ADDENDUM TO INVITATION FOR BID

RE: Addendum No. 3: **IFB-KW-19-244 – Ridge Road Extension – Phase I**

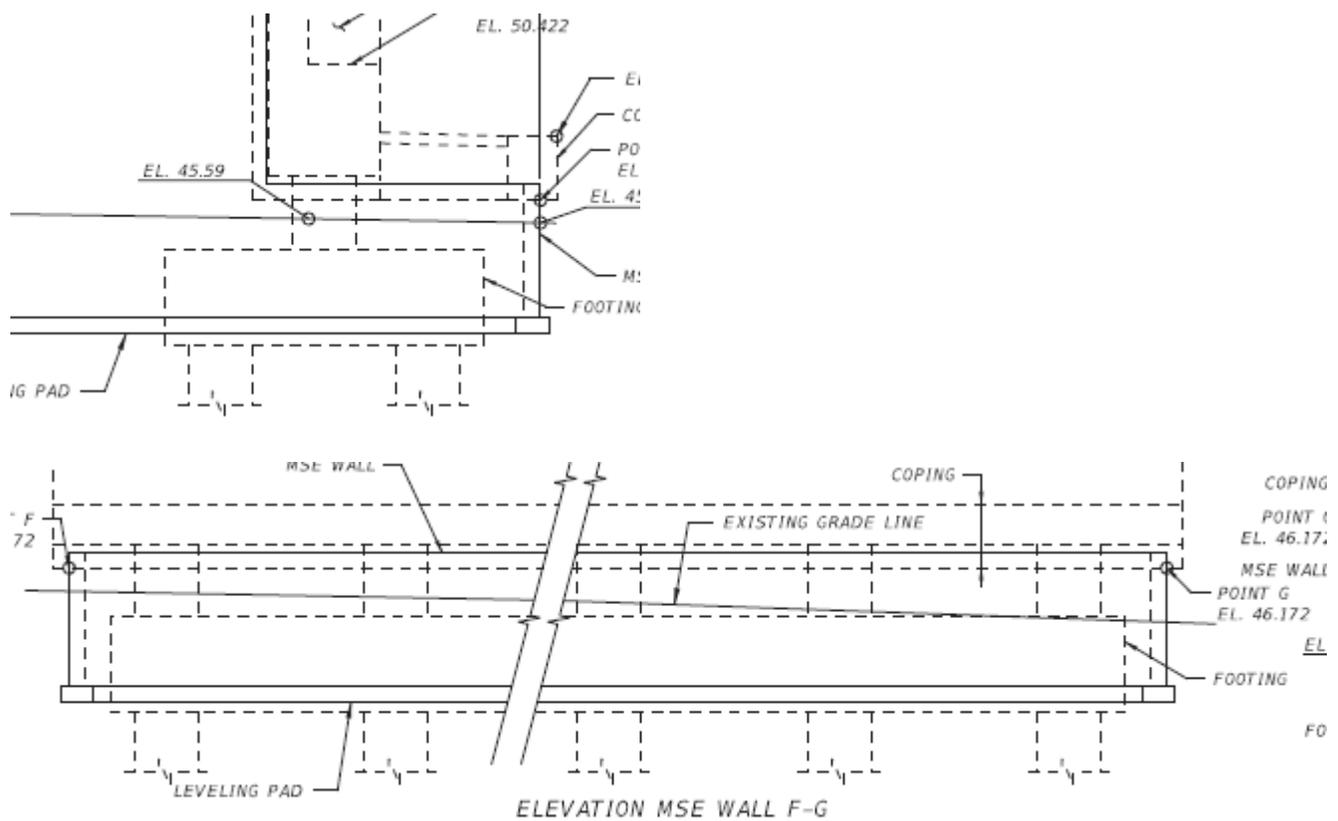
Question 13: There are a couple of sections where the bridge footing will conflict with the MSE wall soil reinforcements. Below is an example from sheet BD-18, but there are several other locations with the similar issue. As it is now, the wall soil reinforcements cannot be installed. Would it be possible to lower the footing? If the top of footing matched the top of leveling pad elevation, we would have plenty of room.

Please let me know if the footings can be lowered or if there is another solution to this issue.

Answer 13: It is acceptable to lower end bent footing so that top of footing matches top of the leveling pad elevation.
